SUBJECT: 20419 MACK AVENUE (BEAUILOFTS) SITE PLAN REVIEW #1 AND VARIANCE REQUEST

Parcel ID: 400-07-0400-09000, Acres: 0.14
Site Plan Review #1
Zoning: C , Commercial Business District
Applicant: Lauren Falzone, Property Owner

Site Plan Review

Figure A: Site Plan, Parking and Dumpster Layout

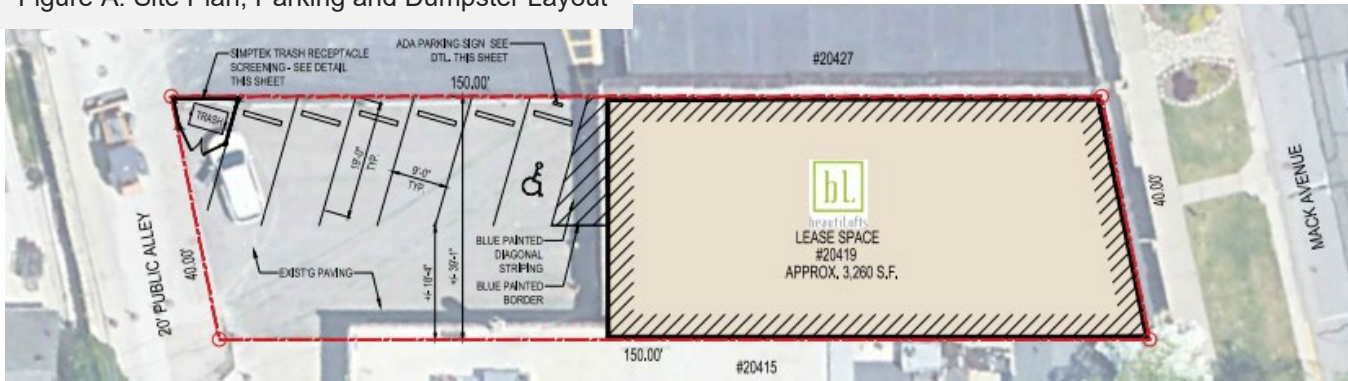
Findings: To screen the dumpster, located at the rear property line in the northwest corner, the applicant proposes gray eco-stone paneled fence at 6 feet high. While the color does vary from the rear exterior of the principal structure, it does align with the pre-approved historical colors for commercial exteriors.

The positioning of the dumpster and its enclosure is not ideal as it blocks the clear vision triangle for vehicle exiting and entering the parking in the rear of the buildings for this property and adjacent properties; however, given the layout and the dimensions of the lot this is the only feasible placement. The Department of Public Works does not expect any issues so long so as there is not an encroachment of the alley.

Six (6) off-street parking spaces are provided in the rear of the building, accessed by the alley. The dimensions of the parking spaces are 9' by 19', angled at 54 to 74 degrees, with a 18'4" maneuvering lane. The following table below shows a breakdown of the number of parking spaces required for the proposed renovation of an existing building. Given that this is an existing structure and the total area of the structure remains unchanged, the off-street parking must only conform to at least 50 percent of the requirements listed above.

Figure B: Construction Plans, Interior Layout

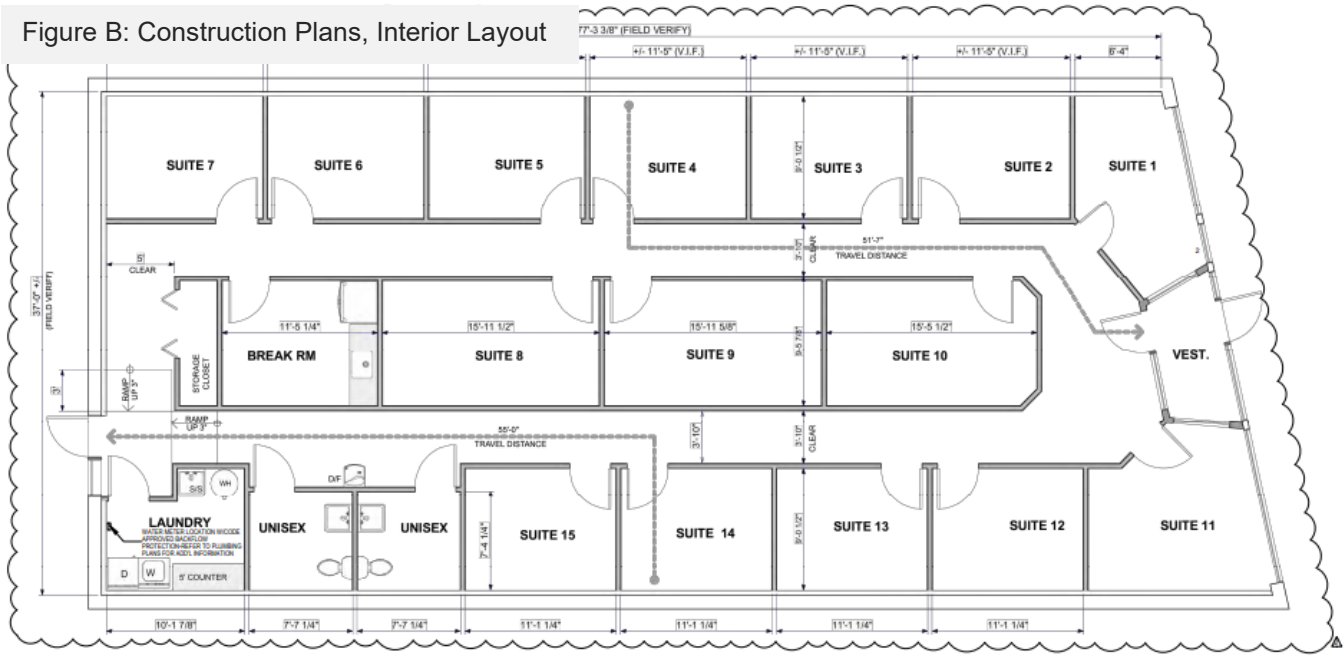
No changes will be made to the building footprint or the exterior of the building. Drawings of the proposed interior renovation and the parking and dumpster layout were submitted along with the application. The applicant proposes to sub-divide the building of 3,260 square feet into 15 rooms ranging from about 100 SF to 159.06 SF. The rooms are to be rented out to an independent beauty-related service providers that assists customers on-site, each service provider chooses their own schedule, it is not coordinated by the facility.

Findings: In considering the context of the site, the provided off-street parking, and on-street parking, there is conclusive evidence to support 11 interior units. There is insufficient parking to support the proposed 15 interior units. **However, Planning Commission should consider whether they find additional evidence to support more interior units based on this review letter, their understanding of the site's context, the business model and additional reasoning provided by the applicant during the meeting.**

The intensity of the proposed use is dependent upon off-street parking. Based on the analysis in this review, it is recommended that 11 interior service units be approved as an intensity that can be accommodated at this location and that the floor-plan be modified and resubmitted for administrative review. This would entail a parking waiver of two (2) off-street parking spaces.
